**DEFENSE NUCLEAR FACILITIES
SAFETY BOARD**

Staff Issue Report

April 21, 2016

SUBJECT: Savannah River Site Nuclear Criticality Safety Program

Figure 1: The SRNS Approach to ANSI/ANS-8.1 Process Analysis Compliance

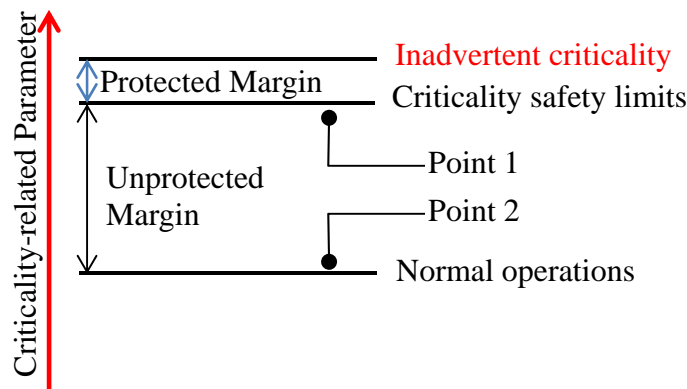
The SRNS approach to process analysis involves the application of two or more controls to prevent operation outside of identified criticality safety limits. Hypothetical operation at the criticality safety limits is considered to be credibly abnormal and is verified to be subcritical via calculation. Operation outside of these limits is considered incredible based on the control set identified. The staff team observed in several H-Canyon and HB-Line NCSEs [6-11] that criticality safety limits often provide minimal margin to a critical configuration. The SRNS methodology is illustrated in Figure 1.

The SRNS process does not prohibit operation near criticality safety limits (Point 1 in Figure 1), though in practice, HB-Line and H-Canyon operations are conducted well below criticality safety limits (Point 2 in Figure 1). The staff team is concerned that the SRNS criticality safety program does not establish appropriate margin in criticality safety limits. The staff team reviewed a subset of SRNS operations that apply margin to criticality safety limits in order to account for measurement, equipment, and process uncertainty. The SRNS criticality safety program and implementing procedures do not require this practice, however, and the staff team notes that it is not uniformly applied by SRNS.

Figure 2: The Board’s Staff Team’s Proposed Approach

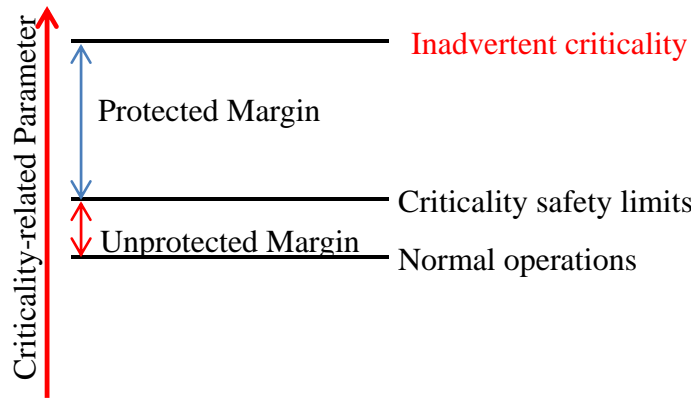
The staff team believes that the SRNS methodology would be better aligned with the ANSI/ANS-8.1 process analysis requirement if appropriate, defensible safety margins were included in criticality safety limits. Safety margin should be identified based on an evaluation of the process so that credible control failures do not result in an inadvertent criticality. As a result, criticality safety limits would be set closer to normal operating conditions. This proposed methodology is described in Figure 2.
